Project	IEEE 802.16 Broadband Wireless Access Working Group < http://ieee802.org/16 >	
Title	Updated OFDM Frame Structure Diagrams	
Date Submitted	2004-03-12	
Source(s)	Lei Wang Wi-LAN Inc. 2891 Sunridge Way, NE Calgary, AB, Canada, T1Y 7K7	Voice: (403)273-9133 Fax: (403)273-5100 Email: LeiW@wi-lan.com
Re:	This is a contribution to IEEE 802.16-REVd.	
Abstract	This contribution describes the proposed changes to add the Transmission Convergence sublayer to the OFDM PHY in 802.16REVd.	
Purpose	To update the OFDM frame structure diagrams according the comment resolutions of WG ballots.	
Notice	This document has been prepared to assist IEEE 802.16. It is offered as a basis for discussion and is not binding on the contributing individual(s) or organization(s). The material in this document is subject to change in form and content after further study. The contributor(s) reserve(s) the right to add, amend or withdraw material contained herein.

Updated OFDM Frame Structure Diagrams

This document provides the updated OFDM frame structure Diagrams, according to the changes from the TGd WG letter ballots.

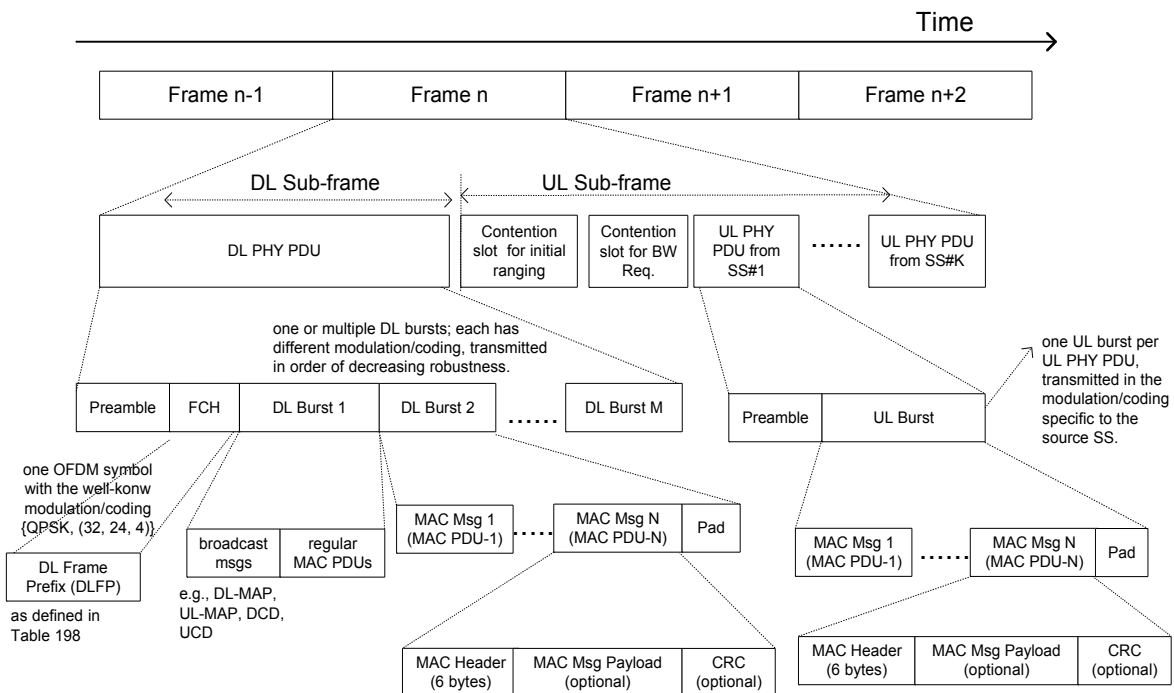
- 1) Page 423, line 35, replace the Figure 201 by the following diagram
